STAFF REPORT
(Preliminary Plat)

CASE NUMBER: SUB 2000-02 -- VAN HORN ADDITION

SUB 2000-02 – Preliminary Plat of VAN HORN ADDITION

STAFF REPORT
(Final Plat, Preliminary Plat Approved 3/9/00)

VICINITY MAP

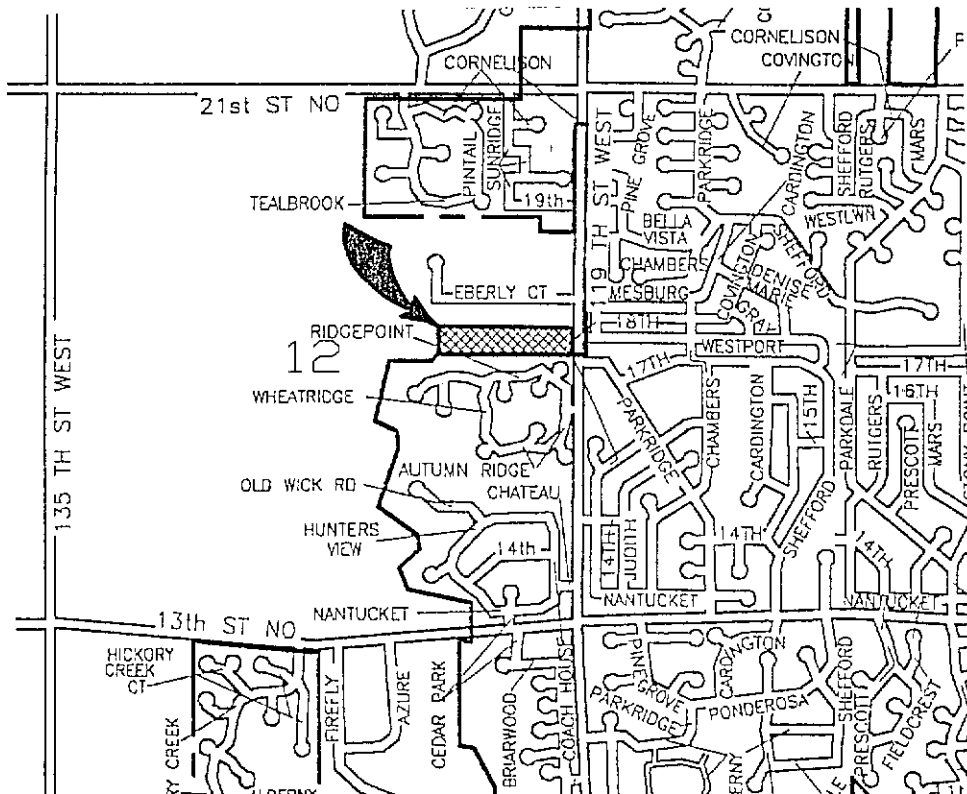
- D. City Engineering needs to comment on the status of the applicant's drainage concept.
- E. The plat proposes complete access control along the site's frontage to 119th St. West. On the final plat, the access controls should be referenced in the plat's text.

- F. The plat proposes the use of an existing private drive along the south property line, Reserve A, to access three proposed lots, in addition to an adjoining lot to the west. MAPD recommends the closure of the private drive and the dedication of a 32-ft street right-of-way along the north property line in order to provide for potential street connections to adjoining property to the north.

- G. A turnaround shall be provided at the terminus of the recommended 32-ft street.
- H. The Applicant shall guarantee the paving of the recommended 32-ft street.

VICINITY MAP

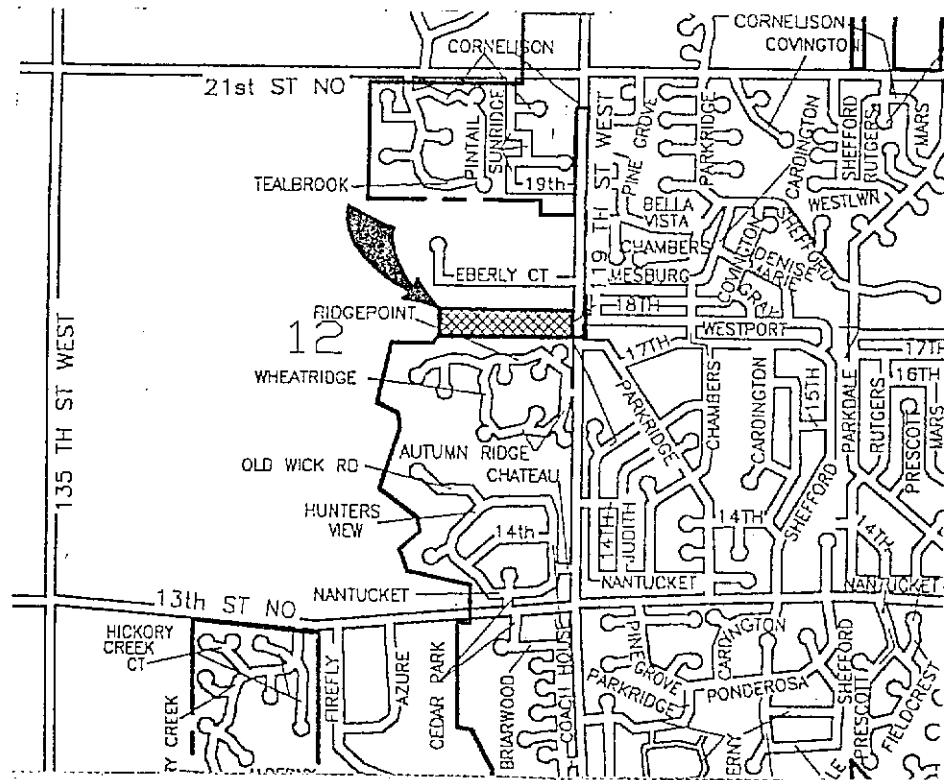
- D. City Engineering needs to comment on the status of the applicant's drainage plan.
- E. The Applicant shall guarantee the installation of the private drive to an all-weather surface.

- F. A definite location needs to be platted for the water line easement on Lot 3 and the west line of the drainage easement on Lot 3.
- G. The contingent street dedication adjoining the plat to the south will be required to be utilized to provide two points of access for City Fire Department and needs to be constructed to an all-weather surface.

- H. City Fire Department requests that "Westport" be designated as a name for the private drive.
- I. The applicant is reminded that a platting binder is required with the final plat. Approval of this plat will be subject to submittal of this binder and any relevant conditions found by such a review.
